ICHD - ENVIRONMENTAL HEALTH DIVISION

Statesville Office (704) 878-5305 | Mooresville Office (704) 660-3625 | PERMIT # AP 320368

SEPTIC: IMPROVEMENT PERMIT / AUTHORIZATION TO CONSTRUCT / OPERATION PERMIT / EXISTING SYSTEM

SUBDIVISION: The Harbour | SECTION: 5 | LOT # 2 | LOT AREA: .66 Acre | DESIGN FLOW: 480 | L.T.A.R.: .3

INITIAL SITE SKETCH

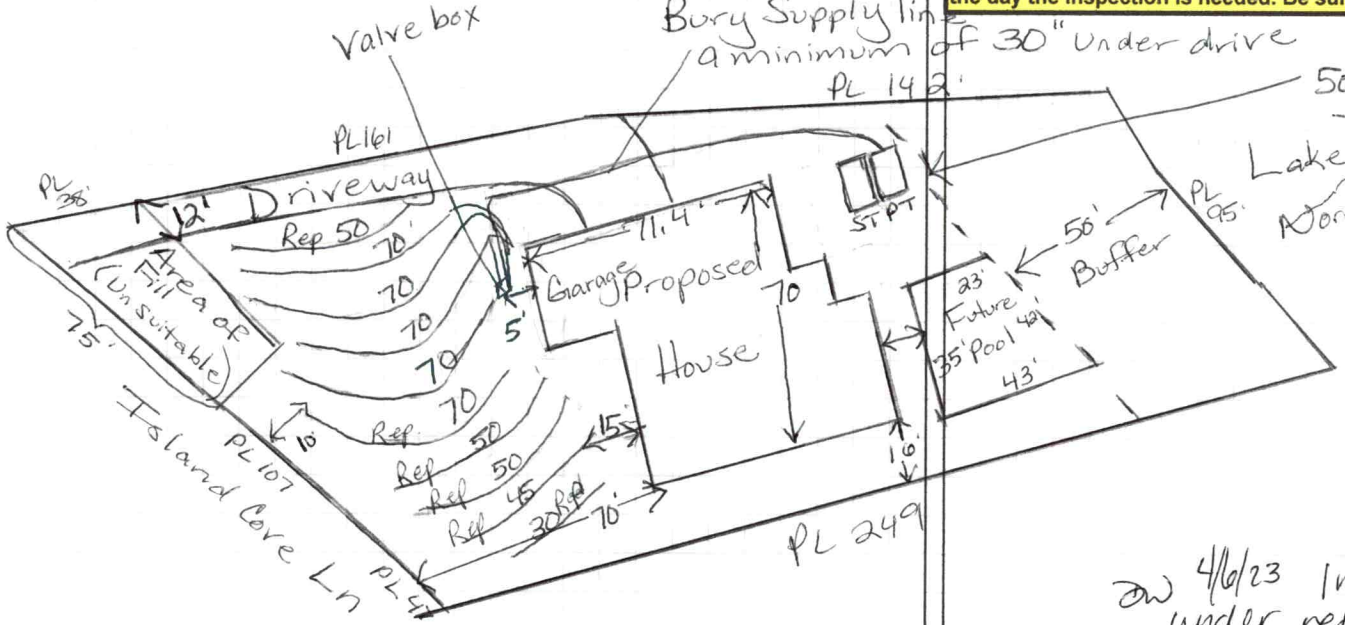
Comments / Conditions: ★Note: 267ft drainfield required but 280ft drainfield layed out. Drill 5/32" hole. Install drainlines 18ft on center

66 Panels - total 237.6 gals dose 41 gpm 27.06 gal/min. Drawdown 11.3 inches Pump run 8.78 minutes. 29 pressure. Install lines on Contour.

★Must build house as Shown. Scale 1:50

50' Buffer must be marked @ time of Septic installation.

★Remove soil from repair - STRONGLY recommend a septic installer do grading to minimize disturbance

AS BUILT SKETCH

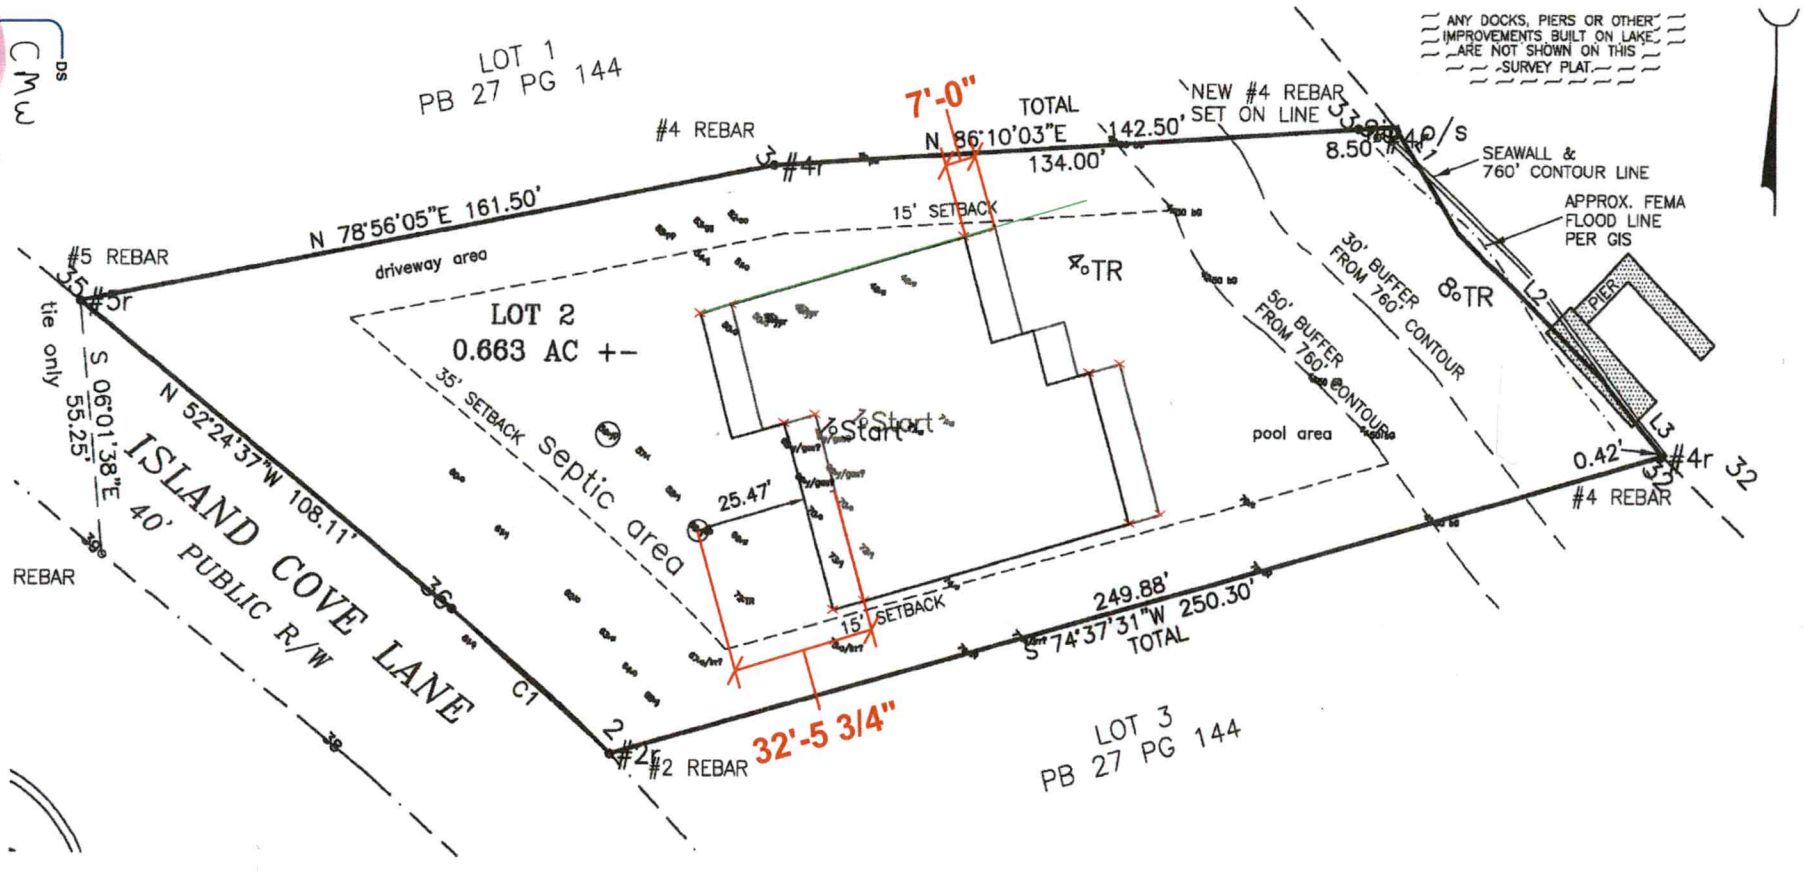
DW 4/6/23 Installed as drawn - Supply under retaining wall & drive >30"; may "cheat" contour for lowest Line - keep fill ≤ 12" over top

INITIAL SITE SKETCH

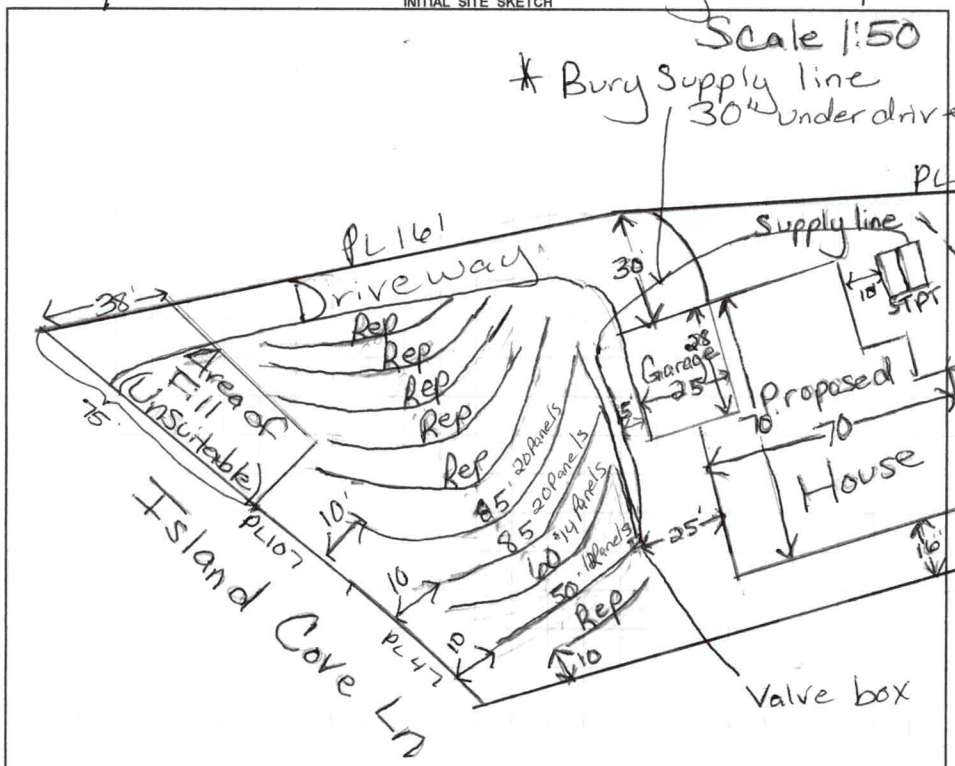
Comments / Conditions: * Install PPBPS drainlines 8ft on center.
* Minimum of 267ft of Drainfield required
Drill 5/32" hole. Divert stormwater away from Septic

66 Panels - total 237.6gals dose
41.9pm 27.0gal/min Drawdown 11.3
Pump run 8.78 minutes. Install lines on contour

Revoked

DO NOT ISSUE BUILDING PERMIT!

FLOOR PLAN STILL NEEDED!
